Technical Service Bulletin: TSB210042

New Exhaust V-band Clamp

Figure 1, New and Old V-band Clamp.

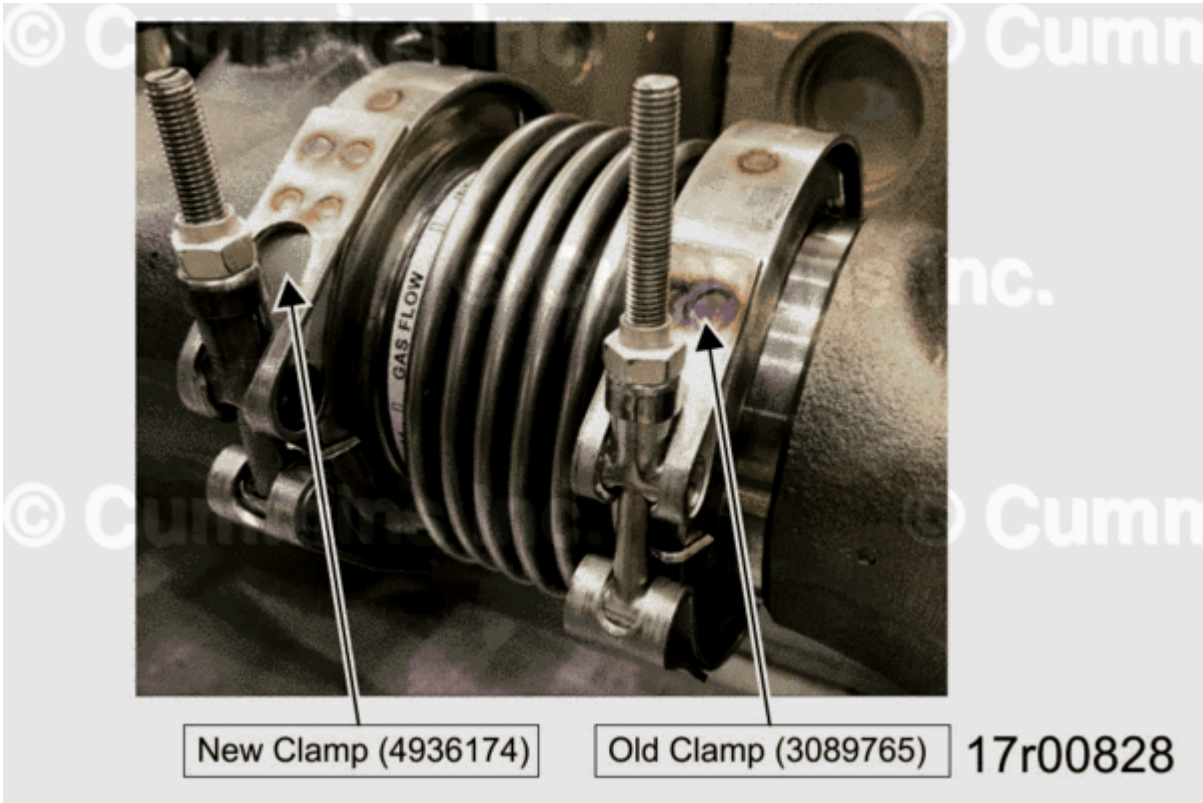
- An alternative V-band clamp is available which utilizes a larger diameter bolt and improved bolt material.
- The new V-band clamp bolt uses A286 material compared to 410SS in the existing design which is less susceptible to corrosion and cracking under increased loads.

V-band bolts have been fracturing, leading to exhaust leaks.

The alternate V-band clamp has a larger cut out in the strap as shown and has a different part number stamped on the strap.

Table 1, Service Parts				
Part Description	Existing Part Number	Obsolete	Superseded	New Part Number
Exhaust V-band Clamp	3089765	No	Yes	4936174
